Product Change Notification / KSRA-18BGHS695

CCB 4559 Final Notice: Qualification of SIGN as a new assembly site for selected SST39LFxxxx and SST39VFxxxx device families available in 48L TSOP (12x20mm) package.

CCB 4559
Pre and Post Change Summary
PCN # KSRA-18BGHS695

Lead frame Comparison

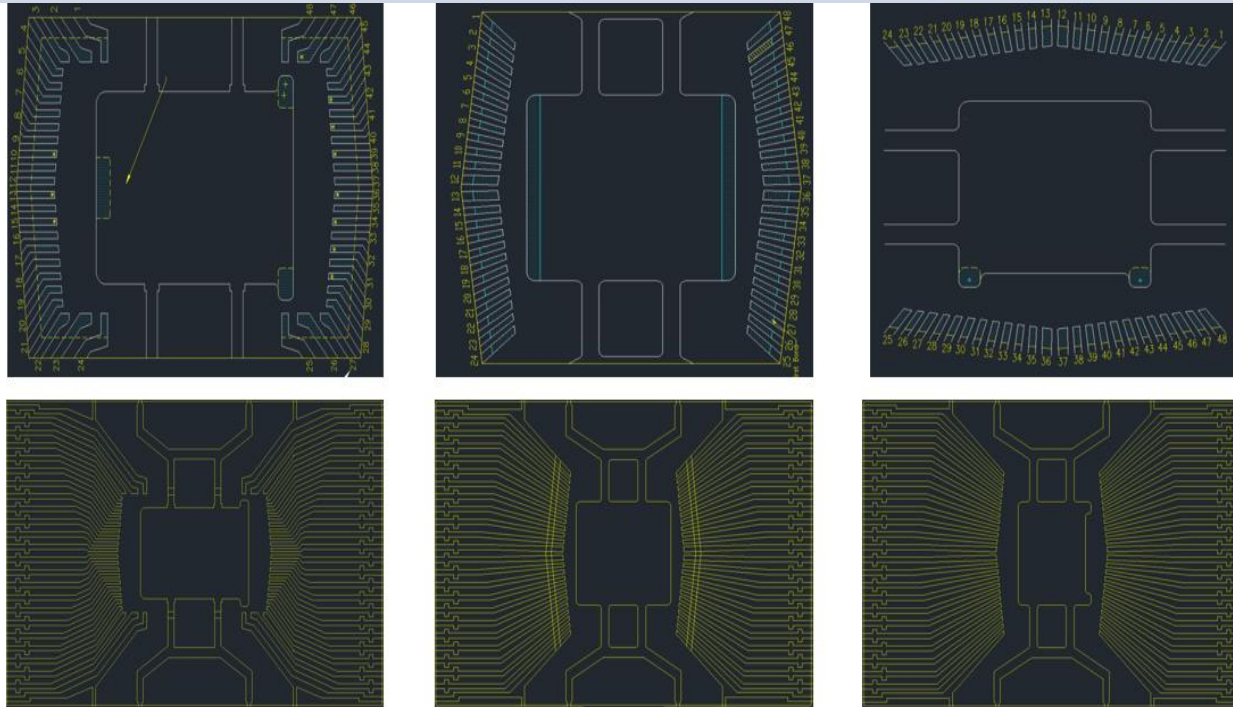
Assembled at LPI using 8340 die attach material and lead frame with paddle size 207x142mils, 183x161mils or 160x130mils.

Pre Change
LPI

Post Change
SIGN

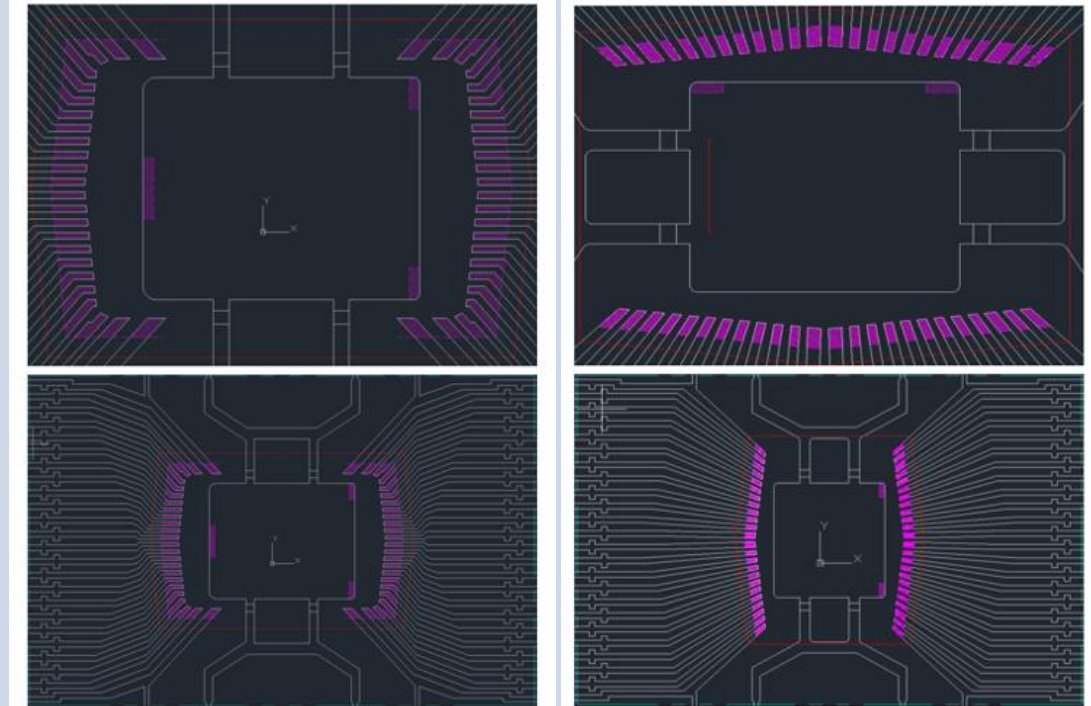
Assembled at SIGN using AP-4300 die attach material and lead frame with paddle size 209x165mils or 159x165mils
